Access Compliance Report

Public Rights-of-Way

(Pedestrian Signals)

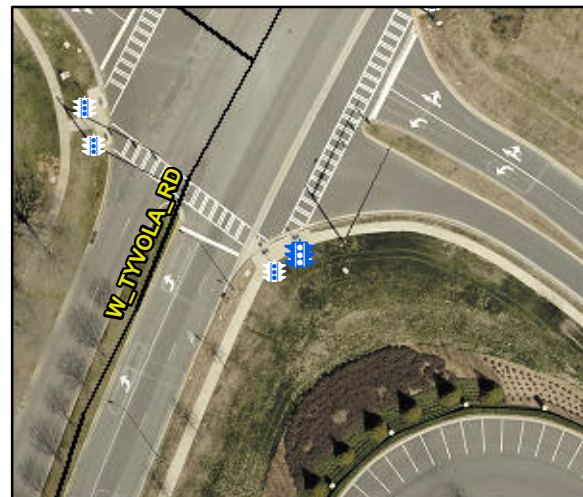
Surveyor Notes: TEXT HT 1/2

PROW/ADA: TMUTCD 4e.08, R410.6, R404.2, R406.2

Compliance	Description	Data	Compliance	Description	Data
	Button Count	Button1	Yes	Distant to Additional Button (in)	204.0
	Additional Button Present?	Yes		Additional Button ID	0A2B0D1FE90E
N/A	Signal Buttons Required?	N/A	N/A	Additional Ped Posts Required	N/A
	How Many Ped Street Xings?	2		Located In An Island/Median?	No
N/A	B 1 Sign Present?	Yes	N/A	B 2 Sign Present?	N/A
Yes	B 1 Sign Purpose?	Yes	N/A	B 2 Sign Purpose?	N/A
No	B 1 Sign Lettering & Contrast?	No	N/A	B 2 Sign Lettering & Contrast?	N/A
Yes	B 1 Parallel To XWalk?	Yes	N/A	B 2 Parallel To XWalk?	N/A
Yes	B 1 PAR to Button?	Yes	N/A	B 2 PAR to Button?	N/A
Yes	B 1 PAR to XWalk?	Yes	N/A	B 2 PAR to XWalk?	N/A
Yes	B 1 Clear Floor Space?	Yes	N/A	B 2 Clear Floor Space?	N/A
N/A	B 1 FWD Approach?	Yes	N/A	B 2 FWD Approach?	N/A
N/A	B 1 FWD Approach Constrained?	No	N/A	B 2 FWD Approach Constrained?	N/A
No	B 1 FWD Approach Reach (in)	5.0	N/A	B 2 FWD Approach Reach (in)	N/A

No	B 1 Clear Xing Direction?	NotClearlyMarked	N/A	B 2 Clear Xing Direction?	N/A
	B 1 Crossing Direction	To NE		B 2 Crossing Direction	N/A
Yes	B 1 DistanceTo XWalk (in)	44.0	N/A	B 2 DistanceTo XWalk (in)	N/A
No	B 1 DistanceTo Curb (in)	110.0	N/A	B 2 DistanceTo Curb (in)	N/A
Yes	B 1 Diameter (in)	2.0	N/A	B 2 Diameter (in)	N/A

Possible Solutions: Replace Signal Push Button With APS Button on New Post. Remove & Replace Sign.
